**SPECIAL MEETING OF COUNCIL
AGENDA**

ENGINEER'S REPORT CONSIDERATION--Esseltine Drain, Town of Kingsville
L. Zarlenga, P. Eng. and K. Vegh, Drainage Superintendent.

THE ESSELTINE DRAIN: ADDENDUM REPORT—BOOK 3

Figure 2: Fernanda Gillis – Property Drainage Route

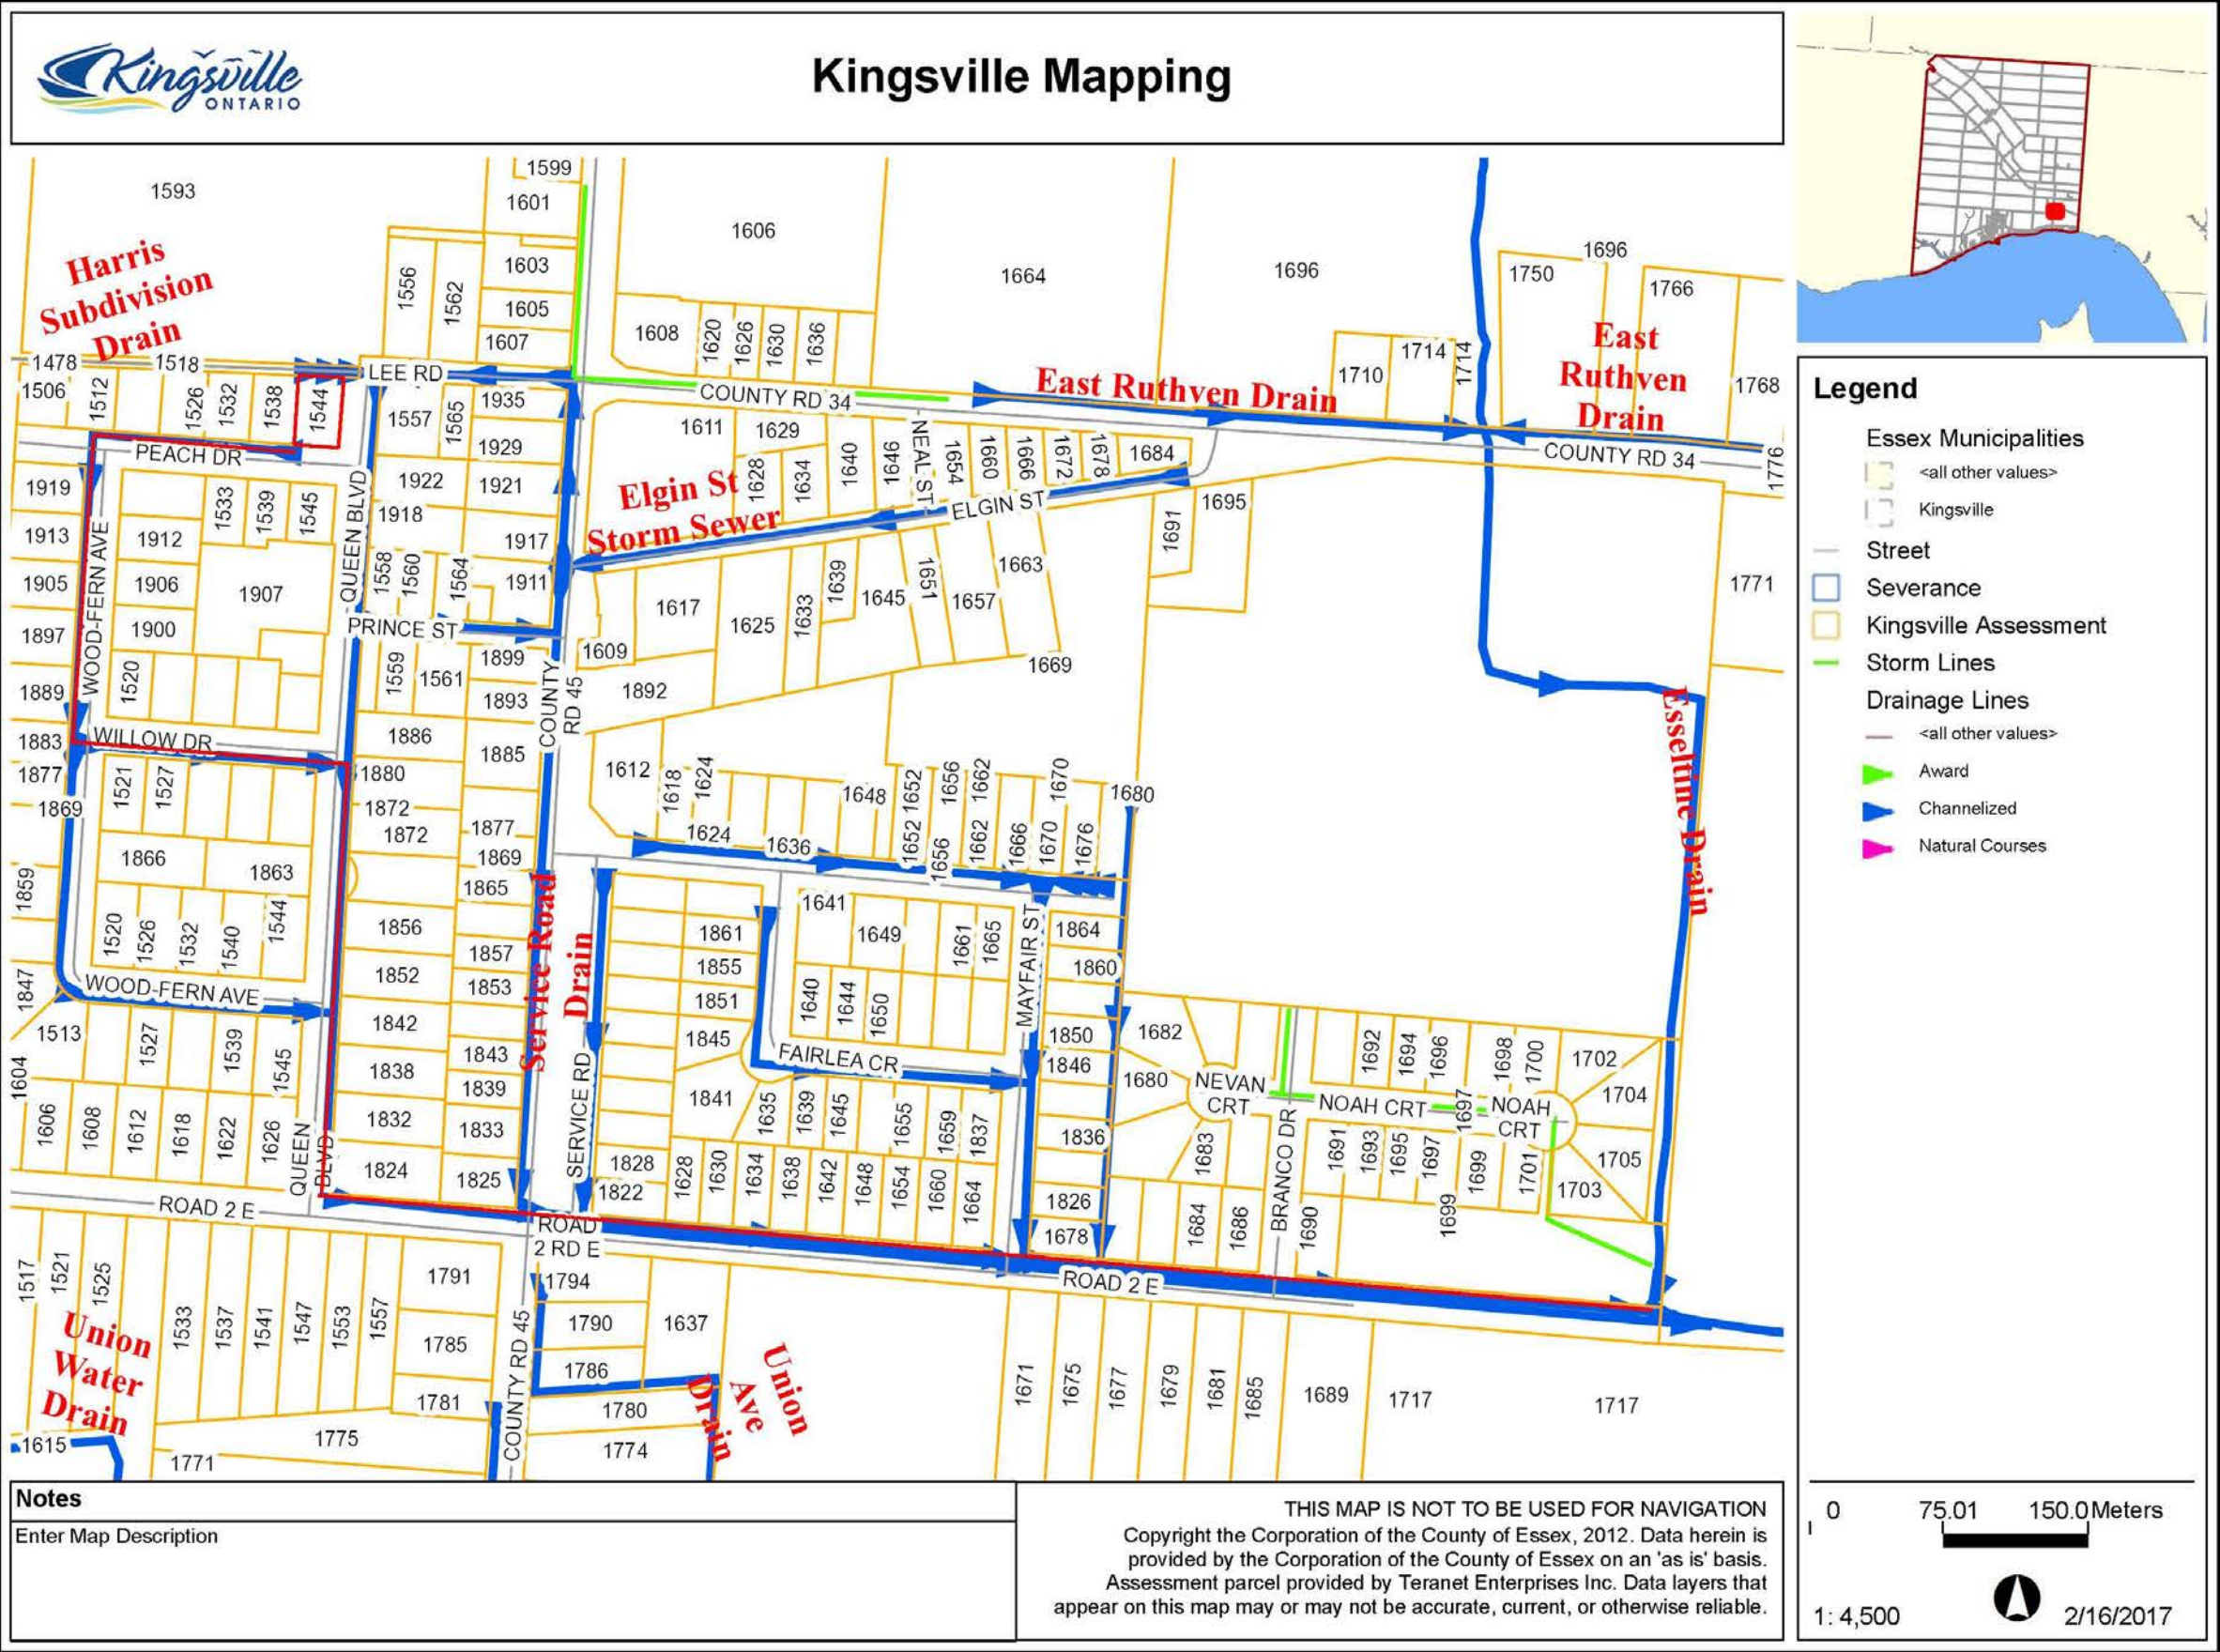
3)	Fernanda Gillis 1544 Peach Drive Roll No.: 300-27400	January 25, 2017	1) Are we draining into Esseltine?	1) Yes, drainage limits have been established. Anyone within the drainage area is under the assessment schedule. 2) We have attached a map showing how your property drains into the Esseltine Drain. Your property (1544 Peach Drive) and the path the water takes into the Esseltine Drain has been outlined in red. Flow arrows are also shown in the municipal drains. - Please see page 11 (Figure 2) for attachment

Figure 3: Frank Mastronardi – Property Drainage Route

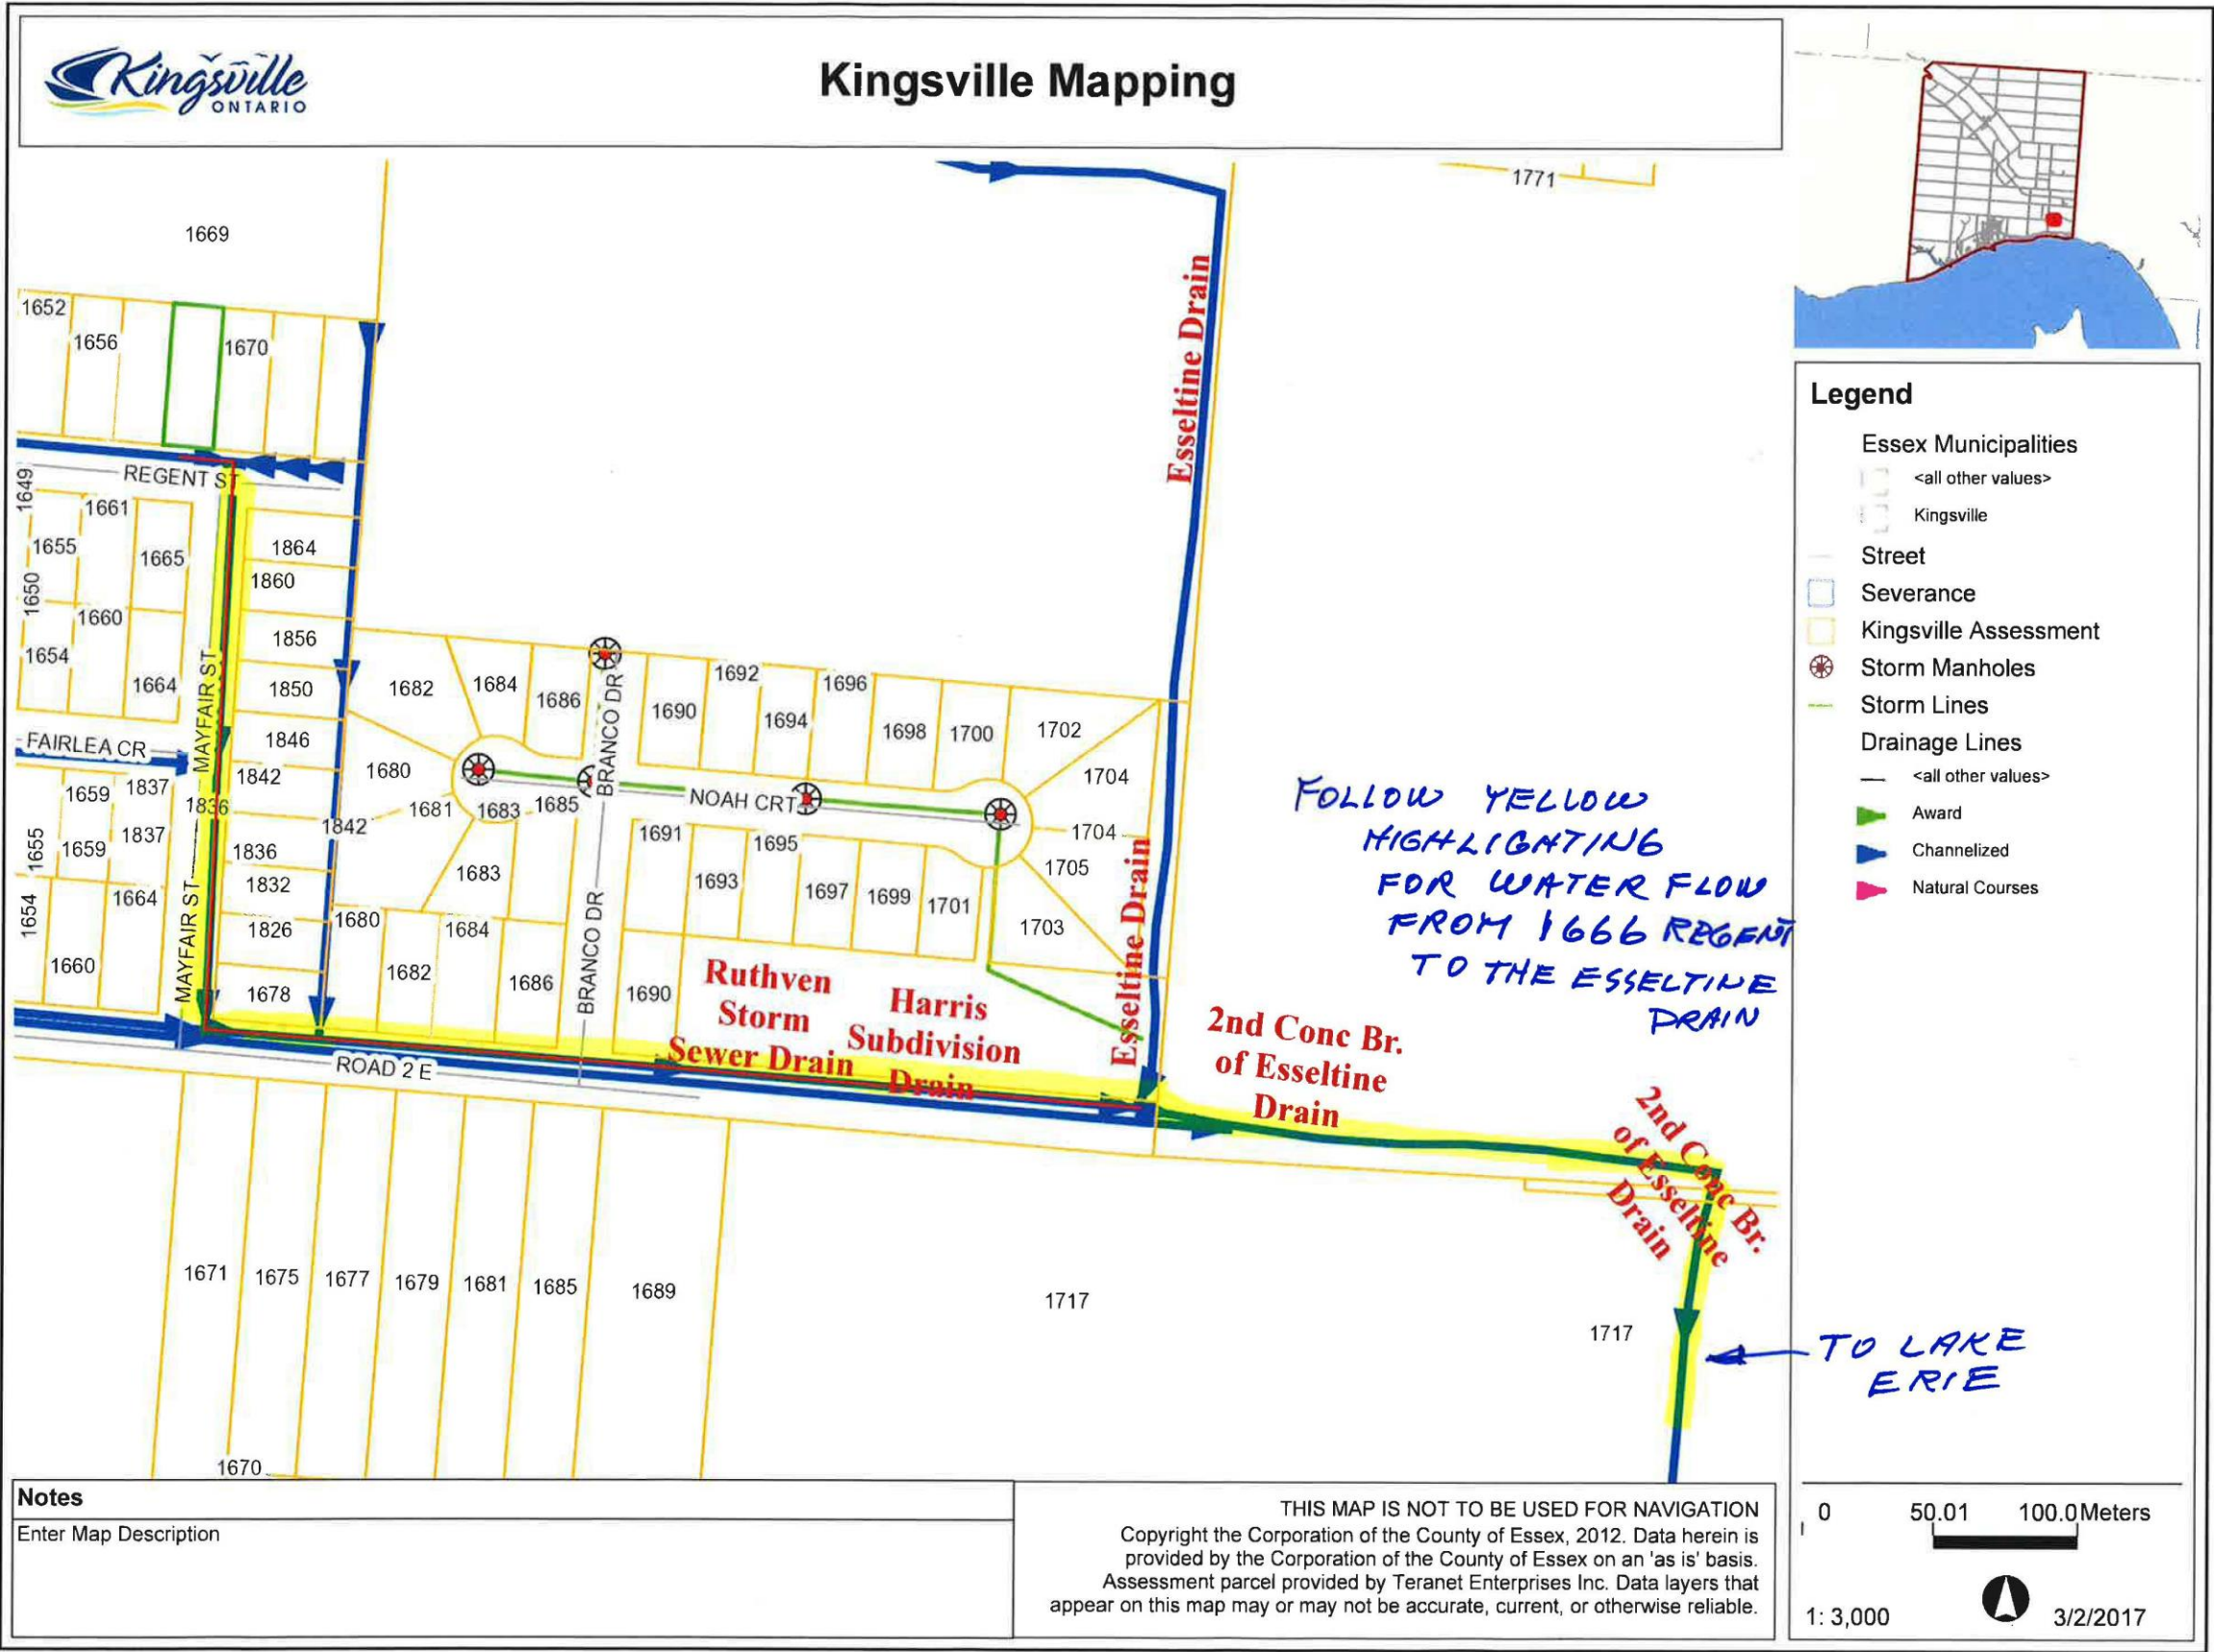
4)	Frank Mastronardi 1666 Regent Street Roll No.: 290-36100	January 25, 2017	1) The storm sewers on Regent Street do not flow into Esseltine, there is water ponding on my property?	1) We have attached a map showing how the water from your property drains into the Esseltine drain through storm sewer systems. Your property is outlined in green and the path the water takes to get to the Esseltine Drain is highlighted in red. - Please see page 12 (Figure 3) for attachment
